Access Compliance Report

Public Rights-of-Way

(Curb Ramps)

Intersection ID: 2899	Main Street: RIDGE_RD	Cross Street: WAVERLY_LYNN_LN	Location: SW
ADA ID: CEF0C7D67767	Ramp Type: Perp	Initial Pass/Fail: Fail	Overall Compliance: No
		Severity Score: 12.5

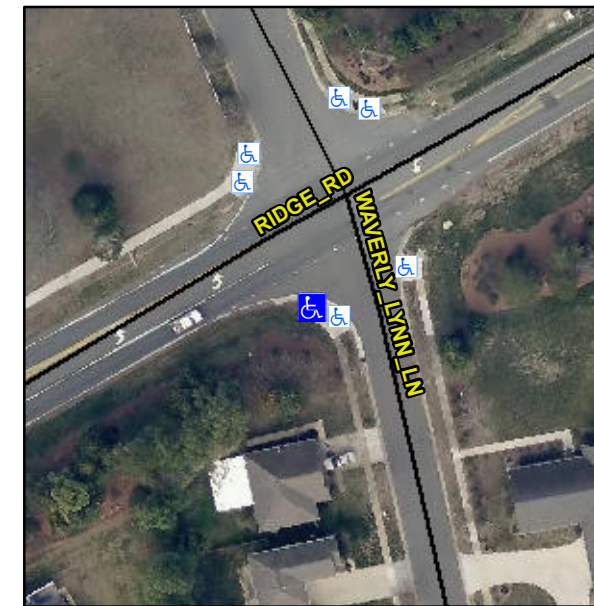
R304.2.2

Compliance	Description	Data	Compliance	Description	Data
N/A	Ramp Length (in)	80.0	No	Ramp Slope (%)	9.8
Yes	Ramp Width (in)	48.0	Yes	Ramp XSlope (%)	1.6
N/A	Flare Type LT	N/A	N/A	Flare Type RT	N/A
N/A	Flare Slope LT (%)	N/A	N/A	Flare Slope RT (%)	N/A
N/A	Flare Traversable LT?	N/A	N/A	Flare Traversable RT?	N/A
N/A	Landing Length (in)	N/A	N/A	DWS Provided?	N/A
N/A	Landing Width (in)	N/A	N/A	DWS Contrast?	N/A
N/A	Landing Slope (%)	N/A	N/A	DWS Length (in)	N/A
N/A	Landing X Slope (%)	N/A	N/A	DWS Full Width?	N/A
N/A	Landing Curb? (Y/N)	N/A	N/A	DWS Offset (in)	N/A
N/A	Shared Landing?	N/A			
N/A	Gutter Ponding?	N/A	N/A	Gutter Slope (%)	N/A
N/A	Gutter Lip Ht (in)	N/A	N/A	Gutter X Slope (%)	N/A
N/A	Painted X Walk1?	No	N/A	Painted X Walk2?	N/A
	X Walk 1 Direction	To N		X Walk 2 Direction	N/A
N/A	X Walk 1 Width (in)	N/A	N/A	X Walk 2 Width (in)	N/A
	X Walk 1 Slope (%)	0.8		X Walk 2 Slope (%)	N/A
	X Walk 1 X Slope (%)	1.4		X Walk 2 X Slope (%)	N/A

Remove & Replace Entire Ramp.
